Local Pattern in ILT (in support comment #463)

Jeff Slavick (Broadcom)

CI 178B	SC 178B.7.3.5	P 860	L 16	# 463
---------	---------------	-------	------	-------

Figure 178B-9 – RTS update state diagram

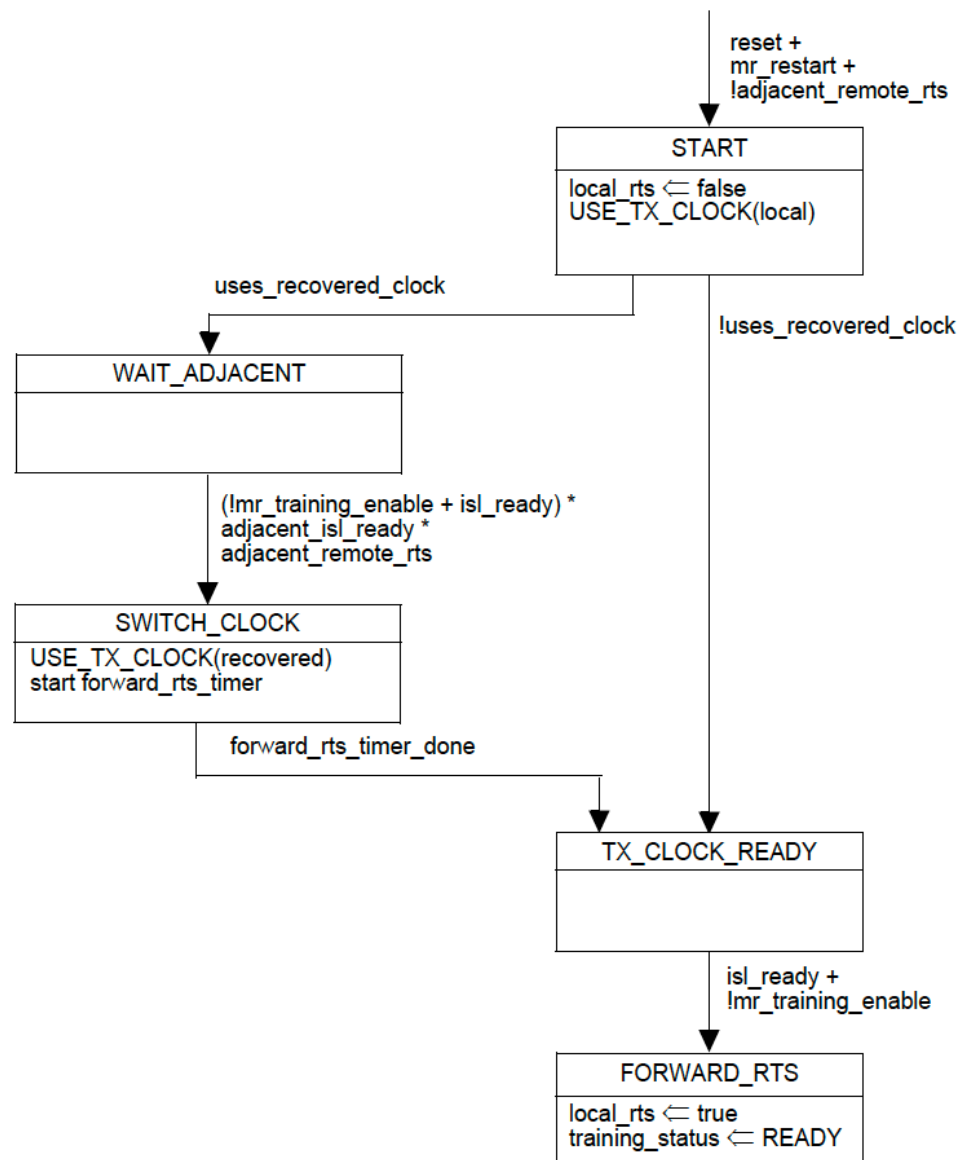
Issue with RTS FSM

We can't identify when to swap to mission clock and has caused some dead-locks in the path-startup process.

RTS FSM controls of the local_rts variable which prevents the transition from the QUIET state to SEND_LOCAL in Figure 178B-10

Figure 178B-10—Training control state diagram

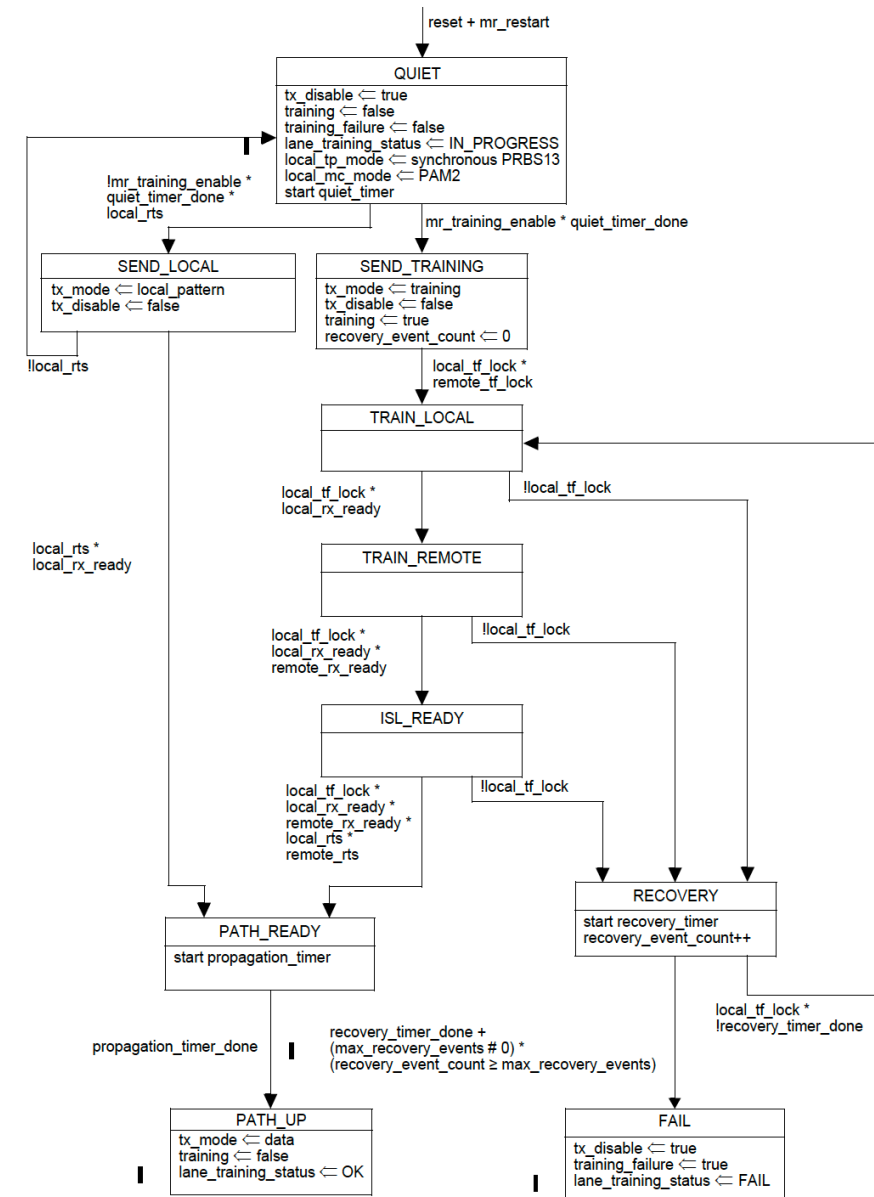
local_rts can't be a requirement to transition into SEND_LOCAL as it requires you to have local_rx_ready in order to assert local_rts which you can't have if you haven't started to send data, which you don't do until you enter SEND_LOCAL

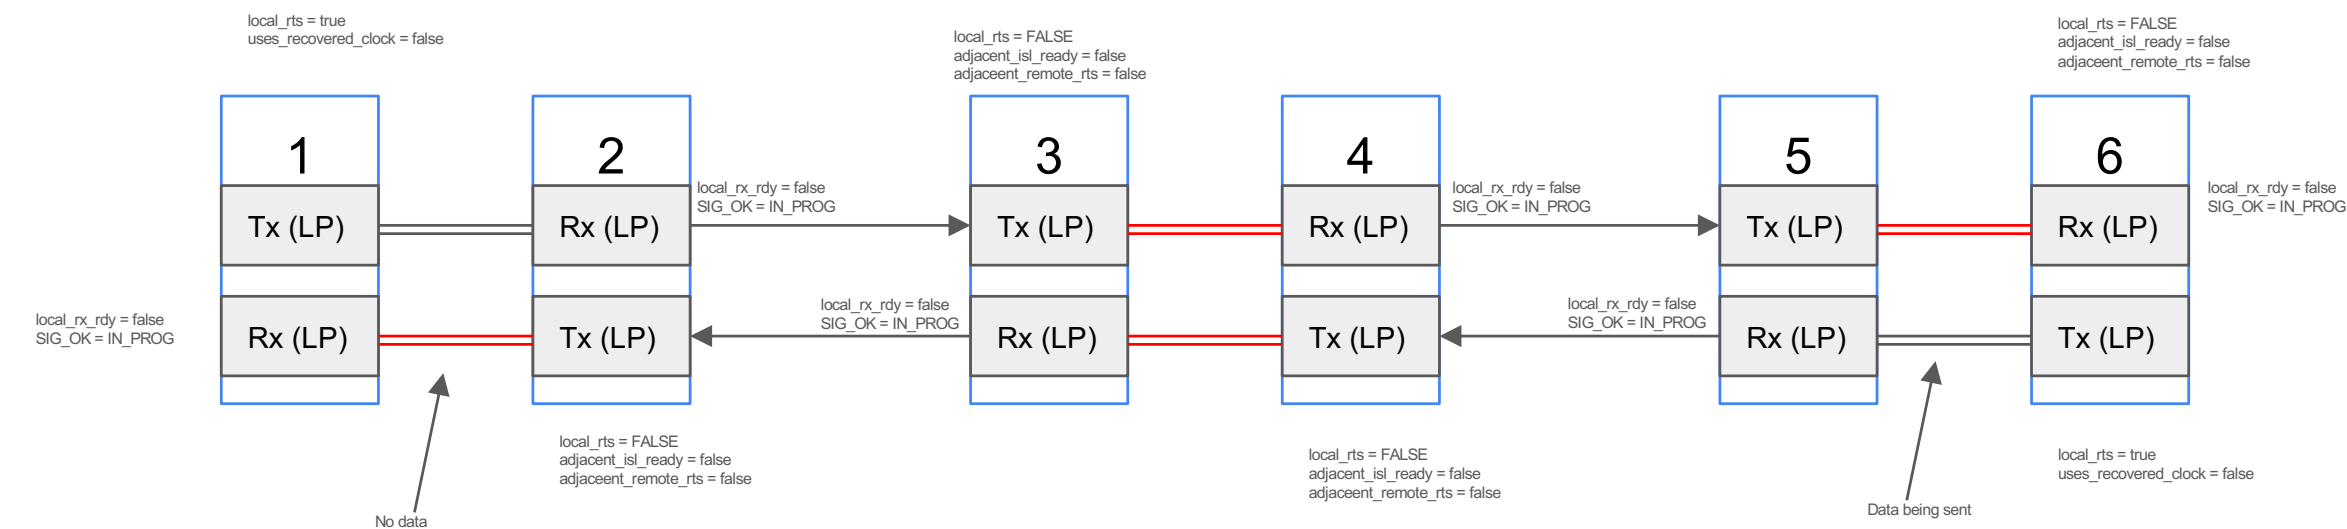
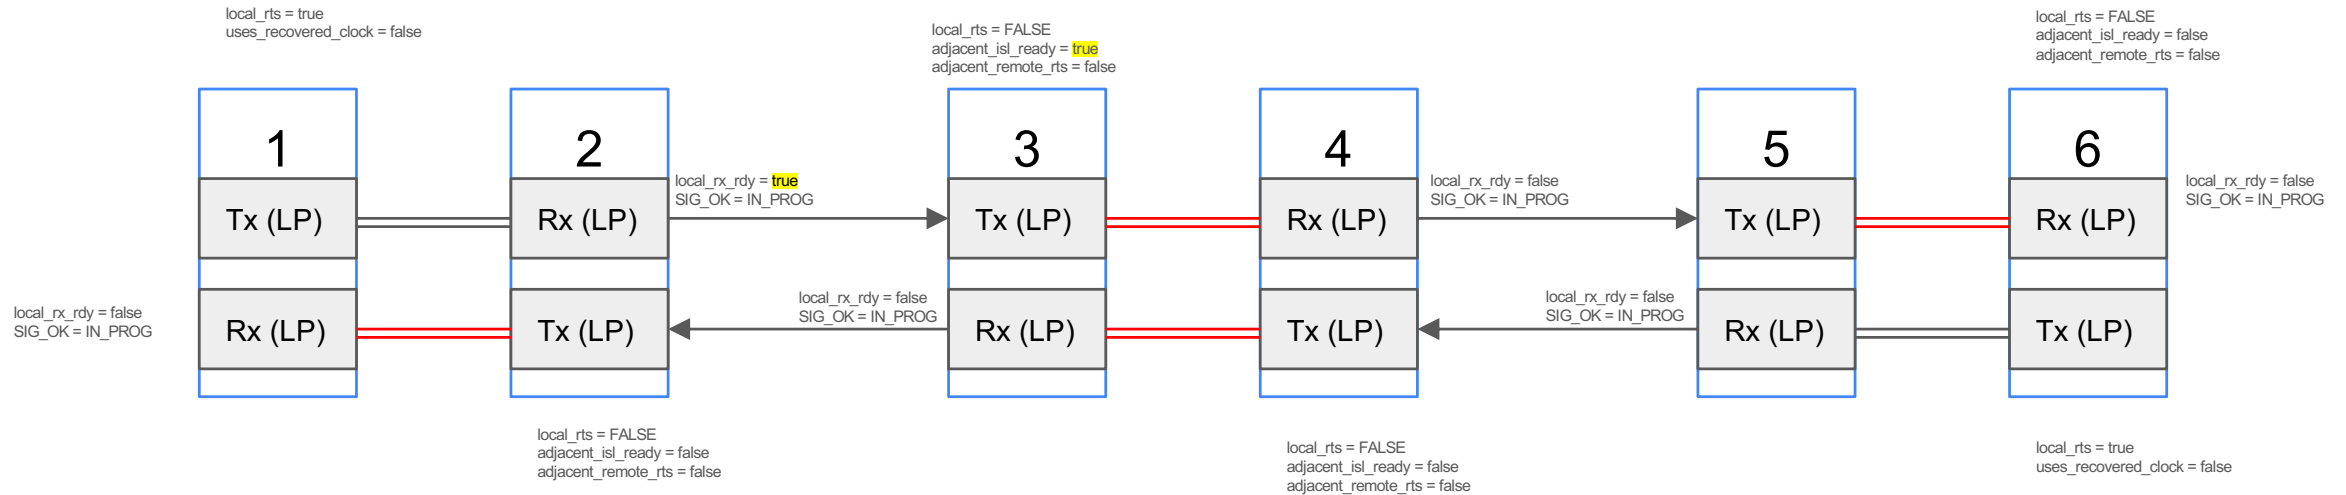
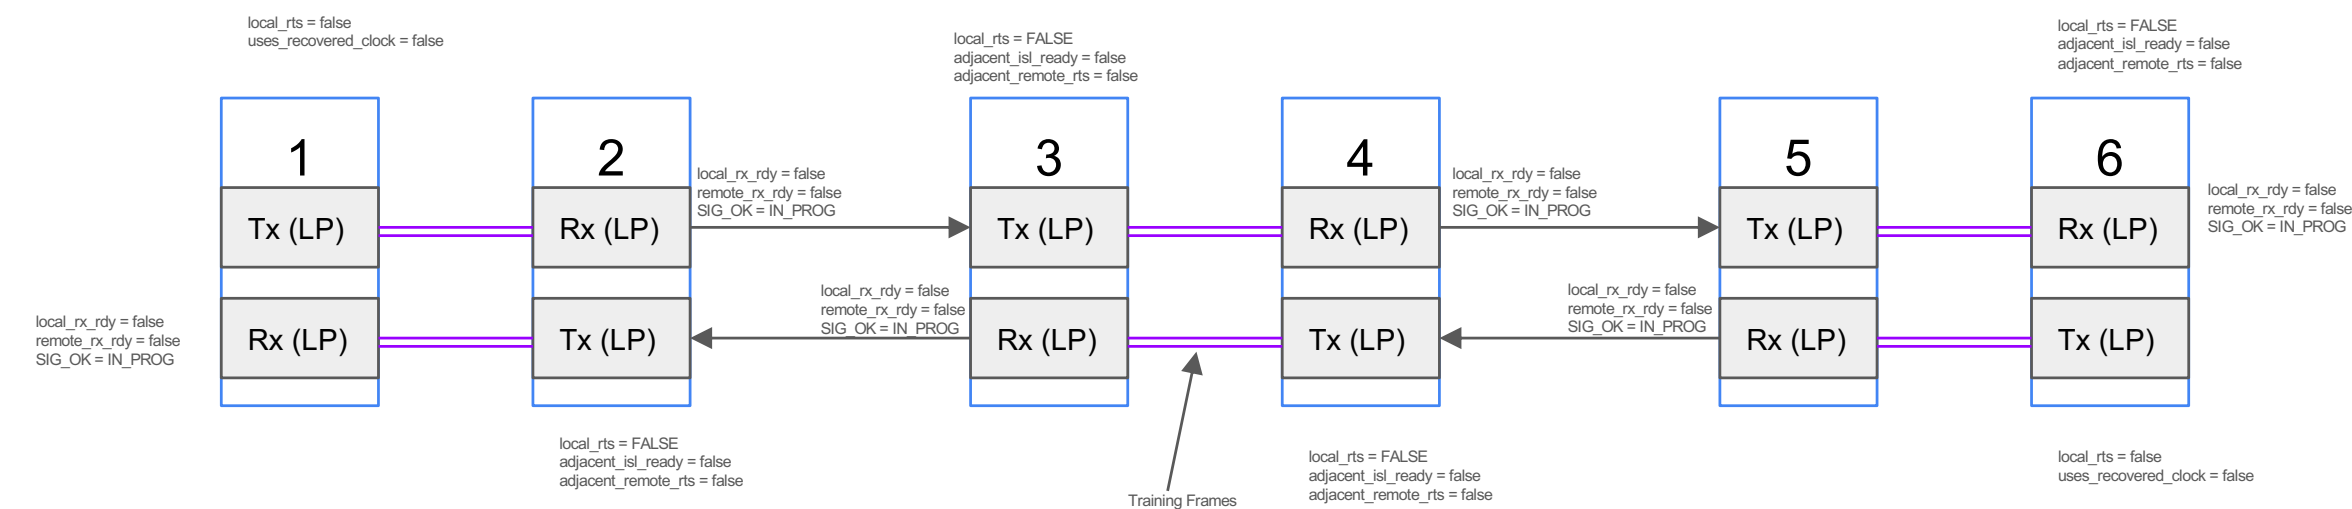
ILT started on all ISLs with mr_training_enable = false

Interface 1 turns on Tx with local pattern.
Interface 6 turns on Tx with local pattern.
uses_recovered_clock = true for ALL interfaces except 1 & 6

ILT started on all ISLs with mr_training_enable = false

Interface 2 Rx is now happy

Interface 3 adjacent_isl_ready is now true

Interface 3 adjacent_remote_rts is false since SIG_OK != OK

Interface 2 SIG_OK towards Interface 3 is still IN_PROG (local_rts is false)

Interface 3 Tx still disabled.

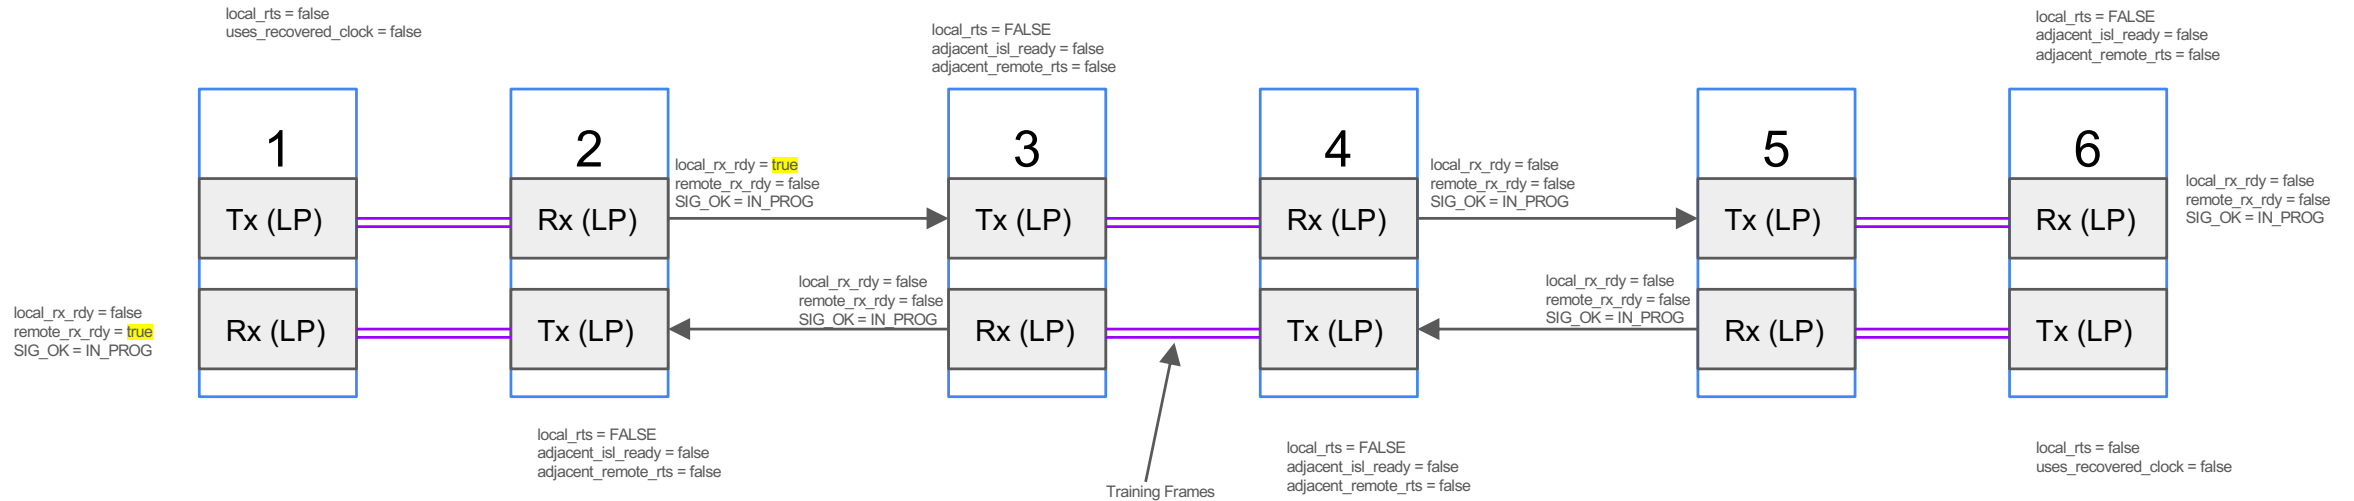
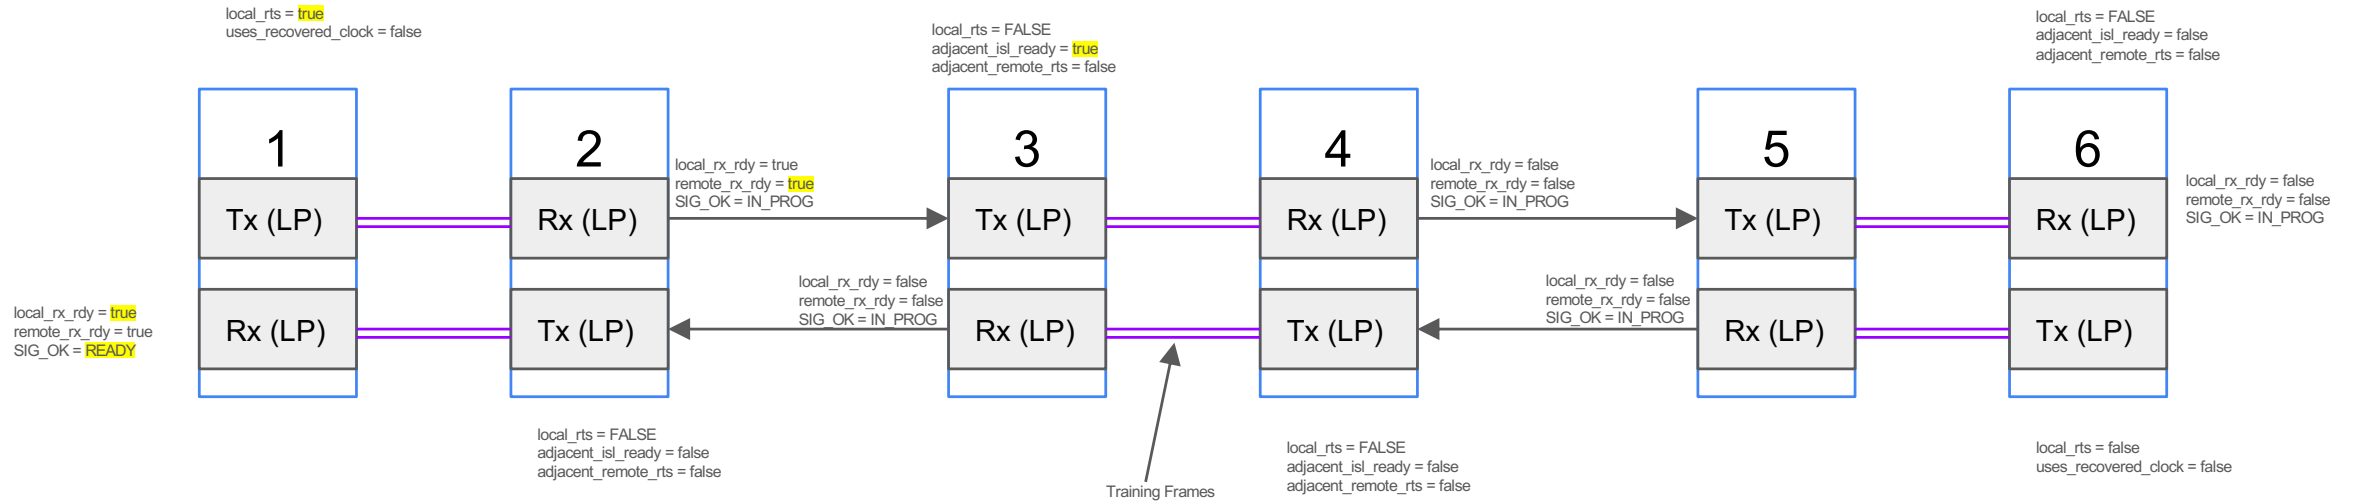
Similar issue exists for training frame mode

ILT: ALL interfaces with mr_training_enable = true

ILT: ALL interfaces with mr_training_enable = true

Rx2 finishes up

`local_rx_rdy = true` for Intf2

`remote_rx_rdy = true` for Intf1

`adjacent_isl_ready = false` for Intf3 since Intf2 `remote_rx_rdy` is false

ILT: ALL interfaces with mr_training_enable = true

Rx1 finishes up

local_rx_rdy = true for Intf1

remote_rx_rdy = true for Intf1

local_rts = true for Intf1

adjacent_isl_ready = false for Intf3 since SIG_OK is still IN_PROG

Figure 178B-9—RTS update state diagram

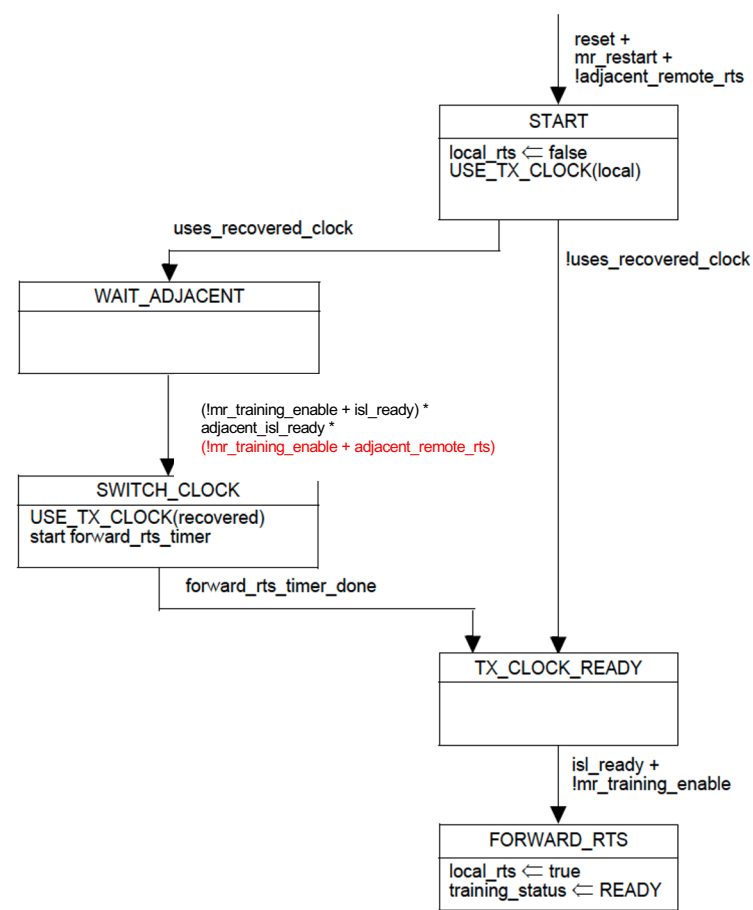
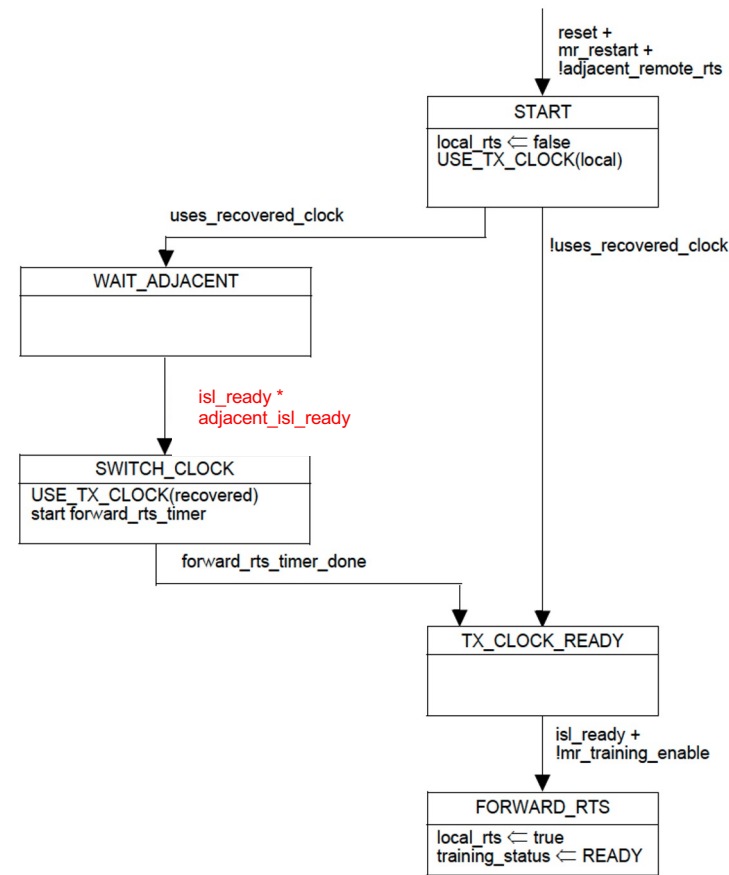
A band-aid fix to address local pattern issue.

Band-aid will cover the local pattern issue.

Figure 178B-9—RTS update state diagram

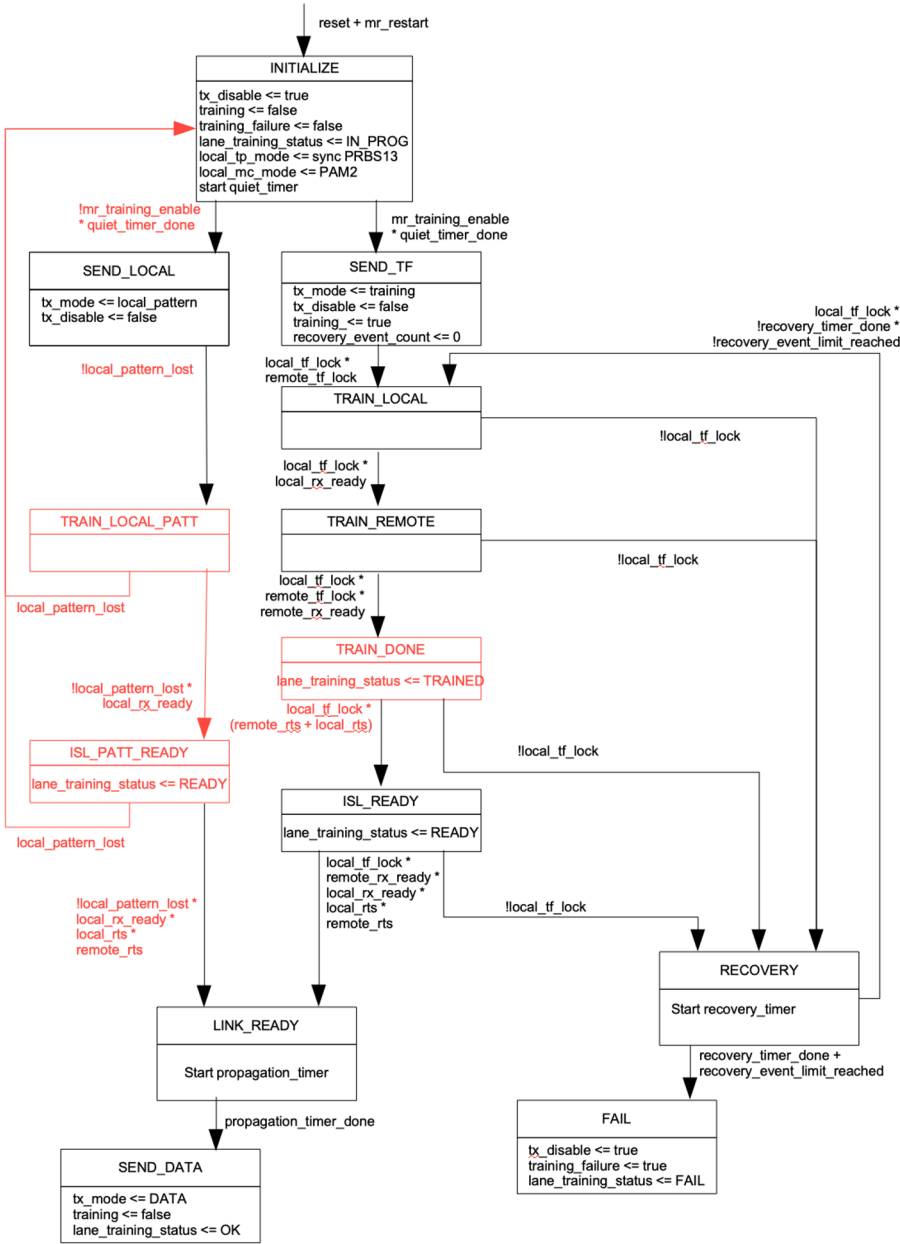
Larger update; add TRAINED state

Adjacent_isl_ready is signal_ok
= (TRAINED | READY | OK)

local_pattern_lost is a loose
pattern/signal_detect

The Larger update attempts to align the local pattern mode of bring-up with training frame mode. Along with providing method to distinguish between the various states of the link state. Which would break the training frame bring up issue.
